VOLUME : 15

General Note on the Green River Proposal

North West Regional Study (FAP2)
Classification for Water Levels for Planning

Upper Karatoya/Bangali Basin

Figure 4 LONGITUDINAL PROFILE OF BANGALI RIVER

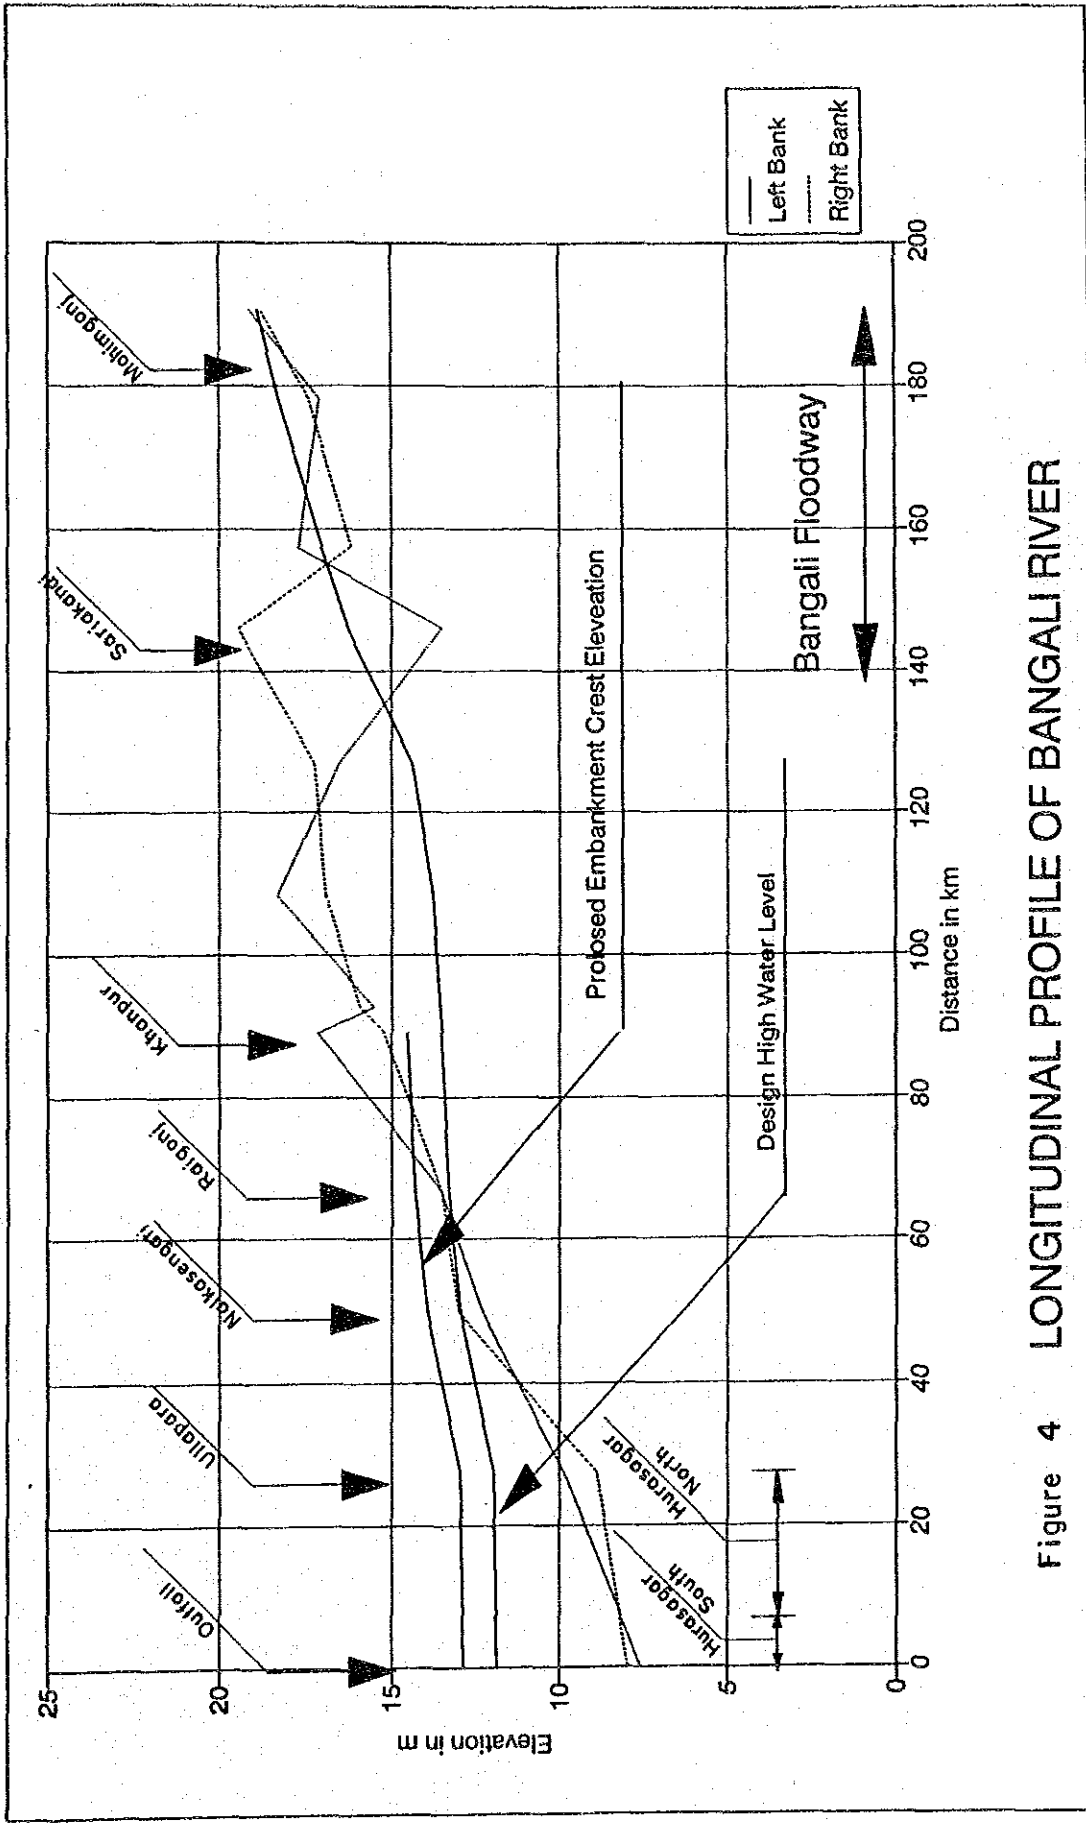
The Figure 4 shows the longitudinal profile of the Bangali river from its outfall to Mohimganj. The Figure shows that the design high water level of the Bangali river in its downstream reaches is higher than the right bank elevation in the reach from the outfall to near Khanpur and higher than the left bank in the reach from the outfall to near Nalkasengati. In consideration of this, flood embankments were considered in these reaches on the respective sides as shown in Figure 2. These plans are presented in the development scenario of the Planning Unit No.14, since these reaches are mainly included in the basin of Lower Bangali Basin. Economic analysis carried out for the regional plan showed that embankments on the left of the Karatoya (which would form part of the Hurasagar North project) are not viable, and these have not been carried further. In the reaches upstream of the Bangali river, high water levels are somewhat higher than the bank elevations but these reaches are included in the reaches of the proposed Bangali Floodway.

Therefore proposals on flood control and drainage of the basin in the Middle Bangali basin for regional plan is the sealing of the BRE, the Gaibandha Improvement Project, drainage improvement by SRP and possible development of the Upper Karatoya in conjunction with the Bangali floodway.
